MOTOROLA

Subject: Request for additional information regarding FCC ID: IHDT5EL1 (Portable AMPS/TDMA Cellular Transceiver)

Application Received:	5/5/2004
Correspondence Reference Number:	240607A.IHD
Confirmation Number:	TC4159
Date of Original Email:	06/07/04

Frequency Deviation with Compander On

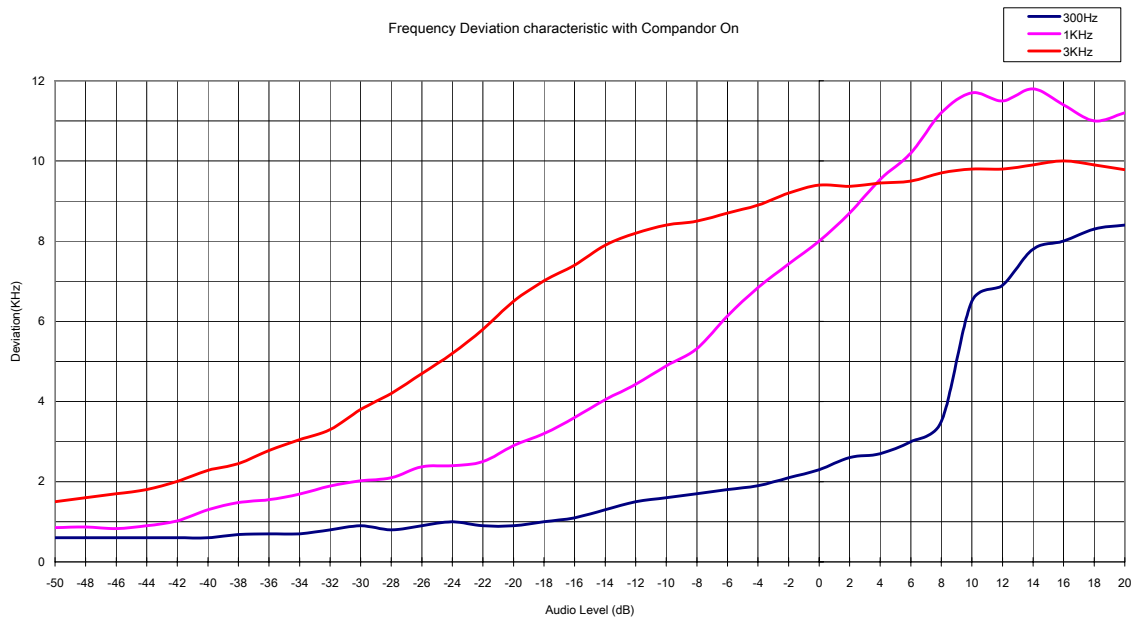
1. Please provide the modulation characteristics plots for AMPS operation required by Section 2.1047.

Response: Please refer to the following plots:

TDMA 800 – Channel 384 (836.52 MHz) – Occupied Bandwidth

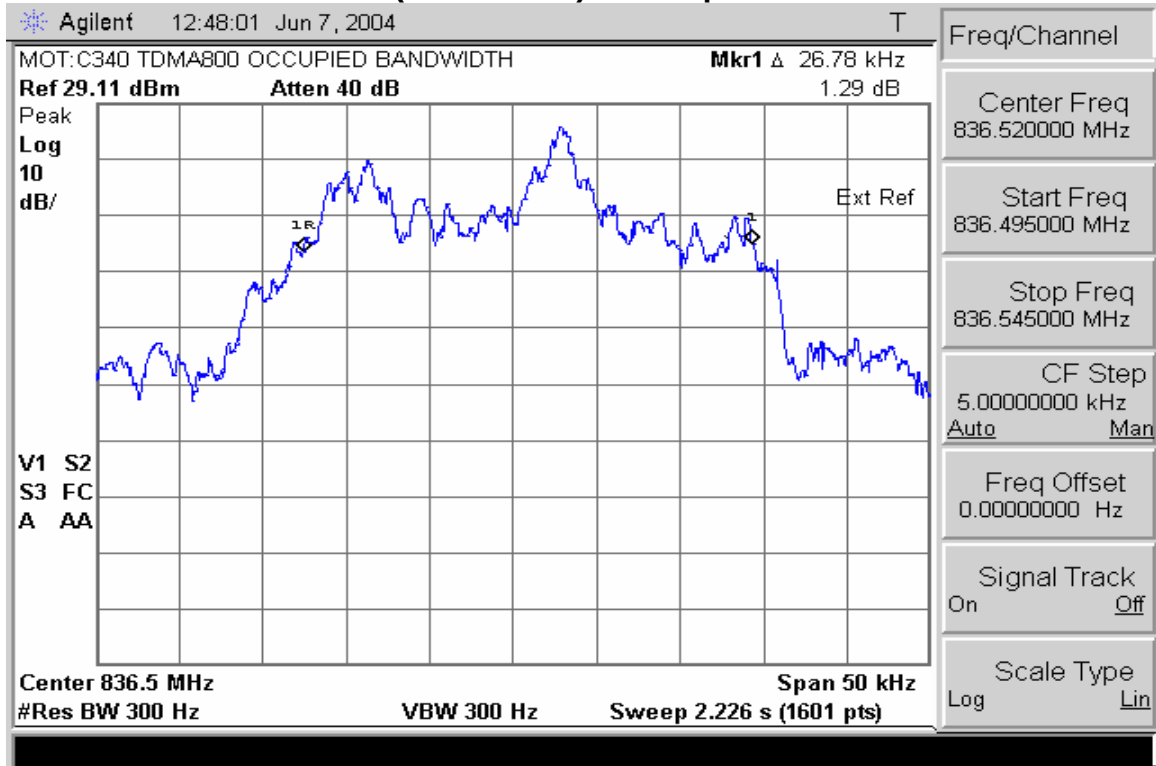
2. Please provide an occupied bandwidth plot for TDMA operation (used to determine the emission designator).

Response: Please refer to the following plot:
